90% CONSTRUCTION DOCUMENTS

**RWRF STORMWATER
IMPROVEMENTS
PREPARED FOR
WOODMEN HILLS
METROPOLITAN DISTRICT
EL PASO COUNTY
COLORADO**

V2_Construction Drawings (Plans-Profiles).pdf Markup Summary

STORM PLAN & PROFILE

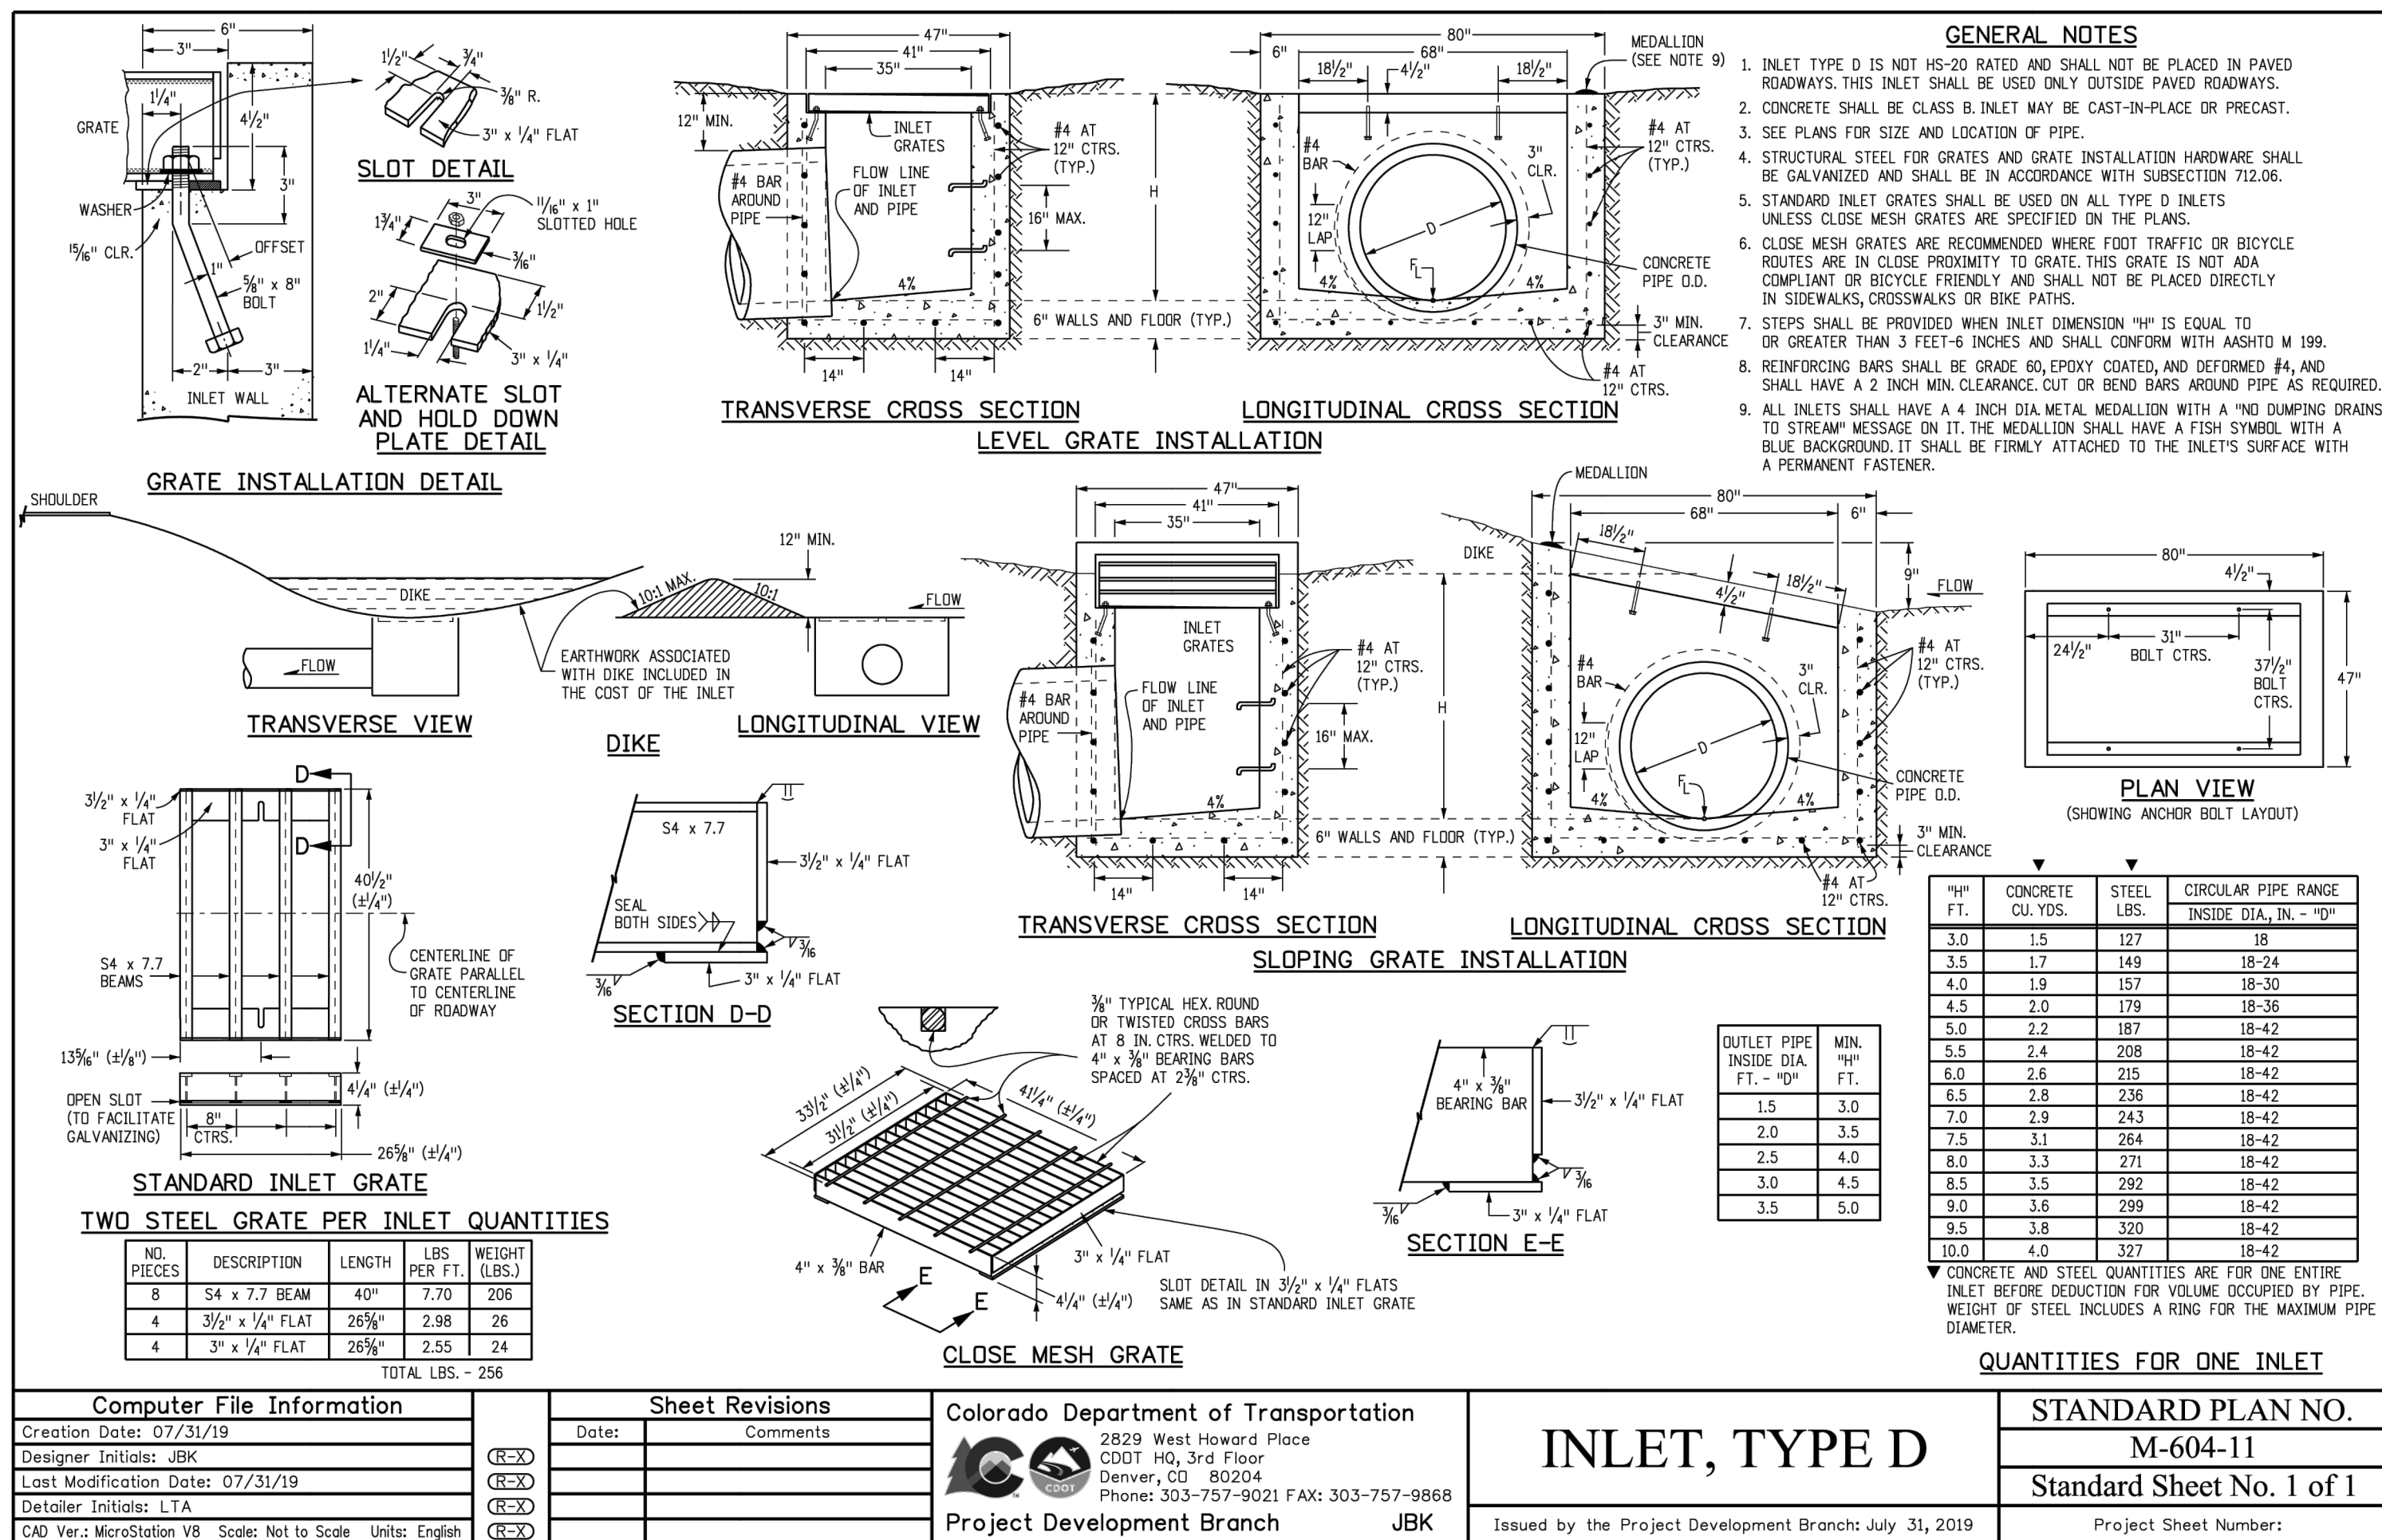
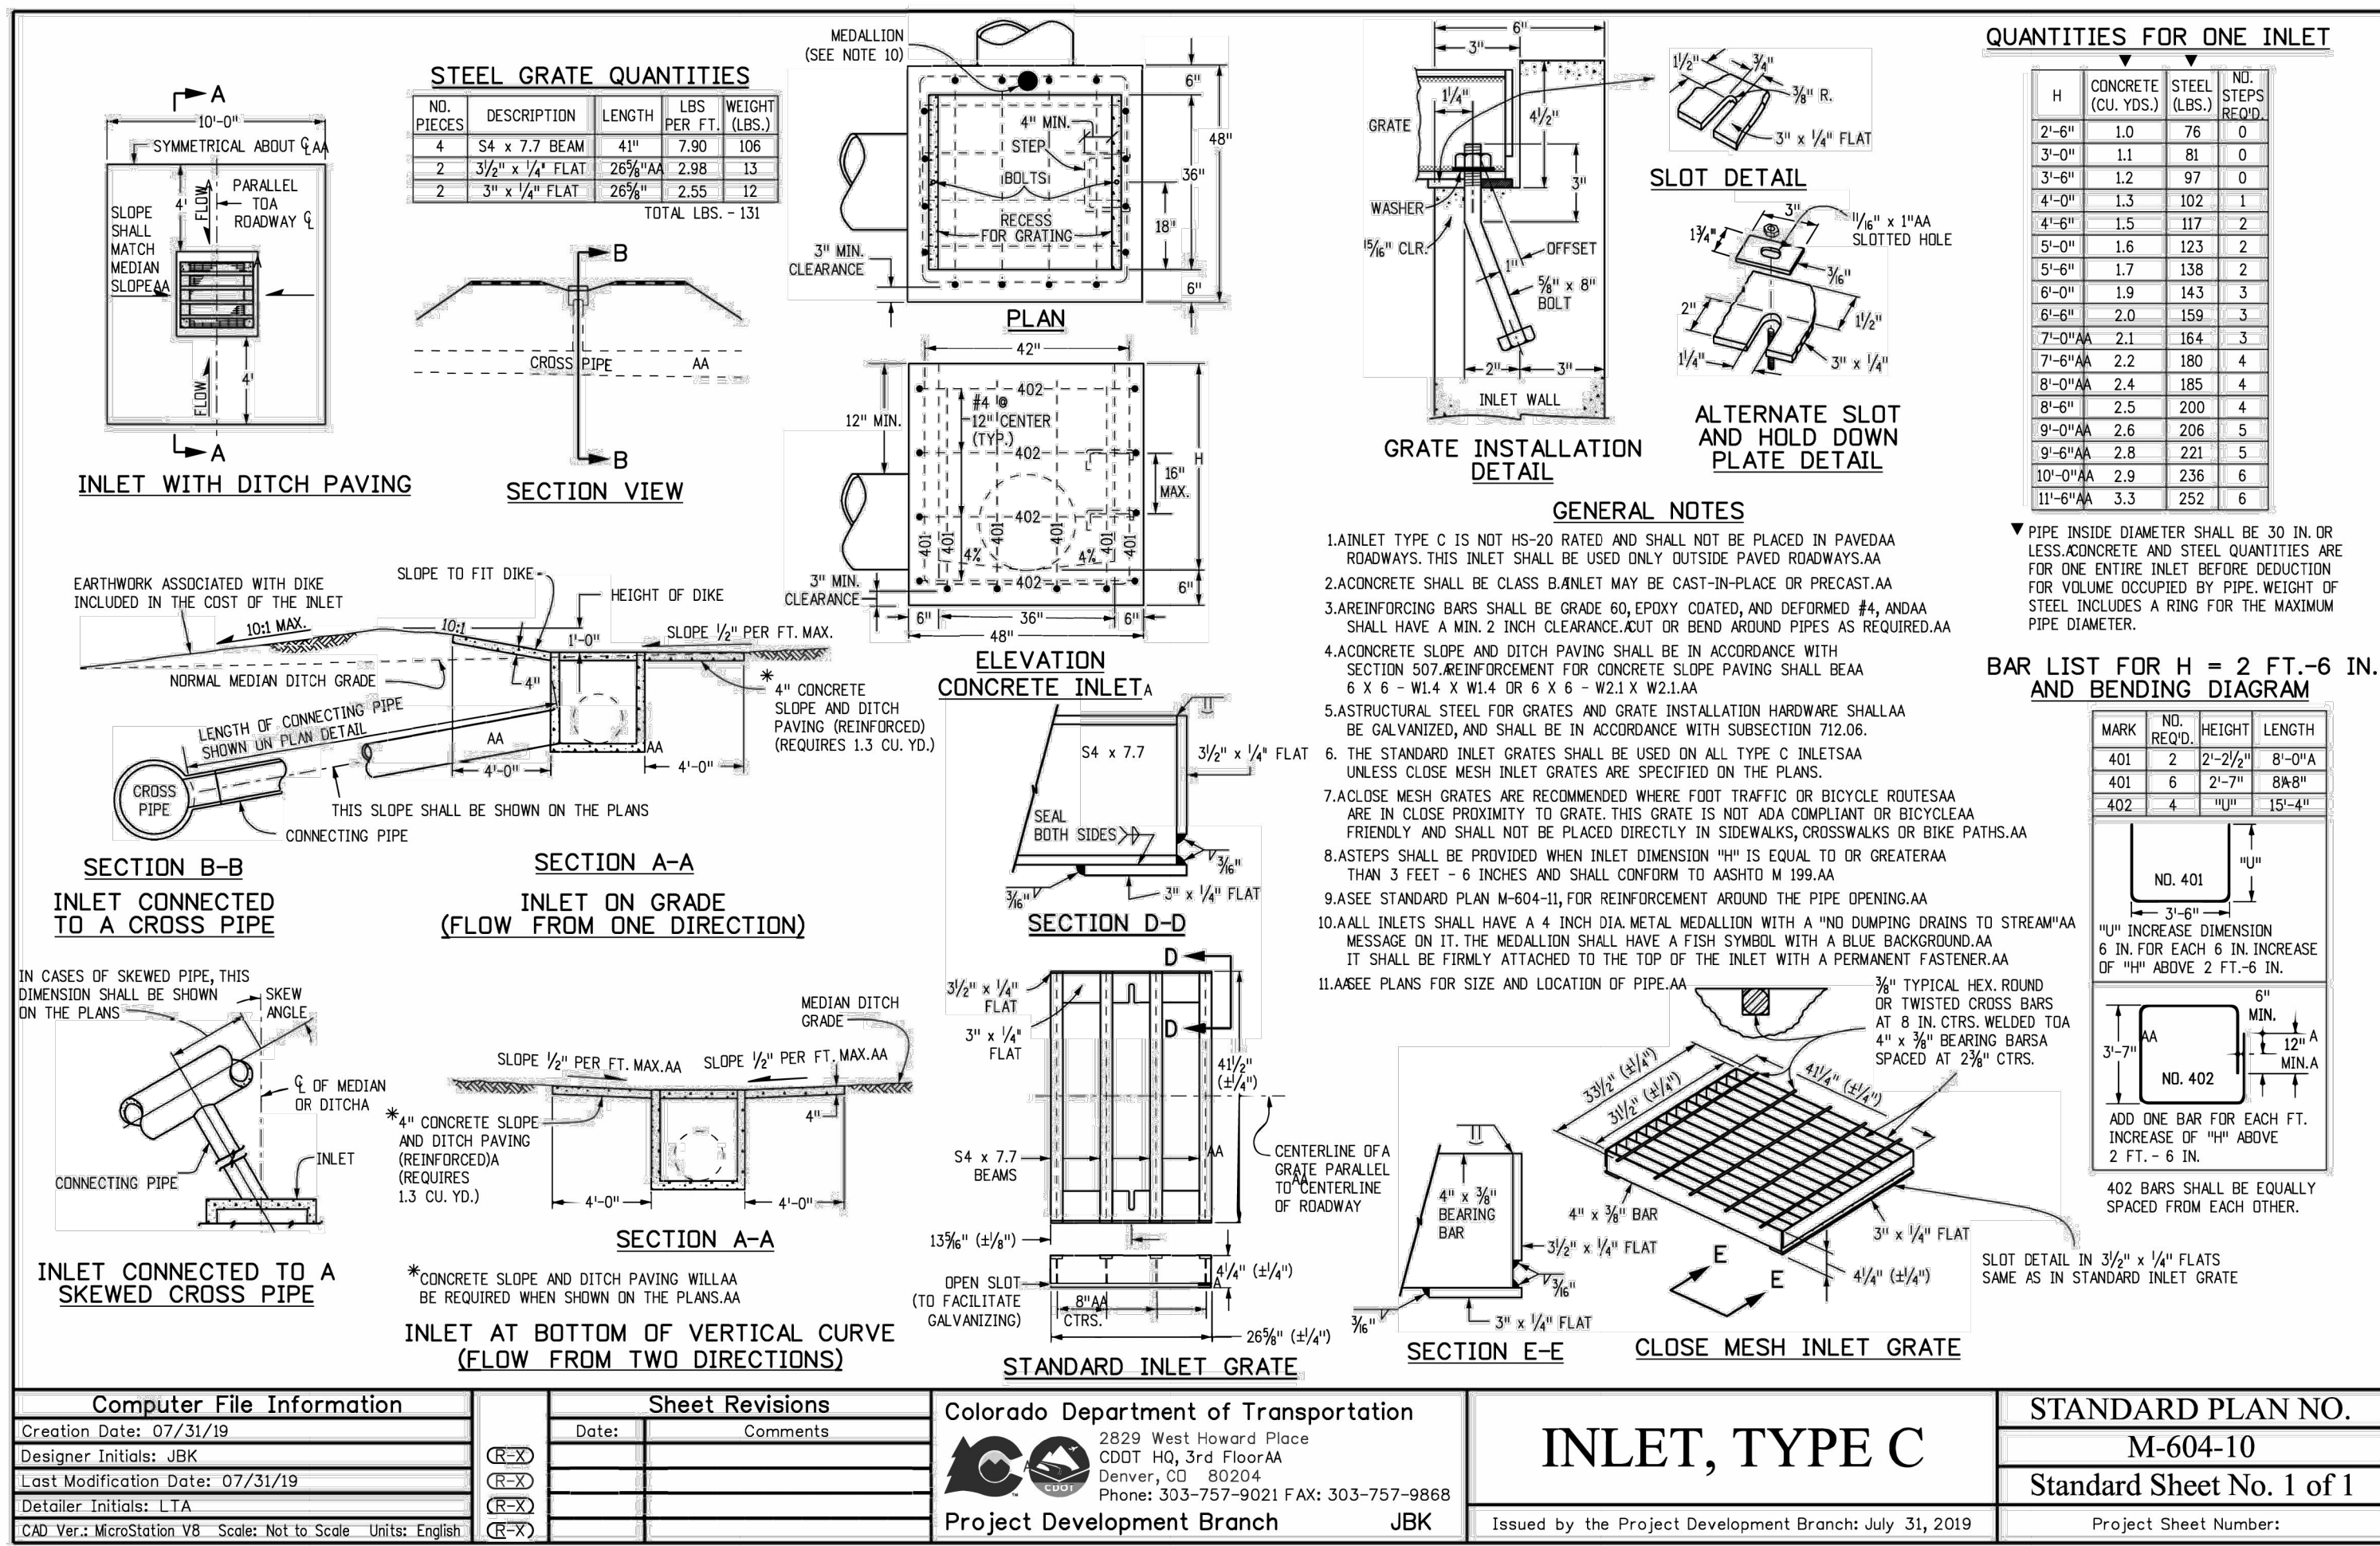
A Type C inlet is not vehicle load rated per the detail notes. Please revise.
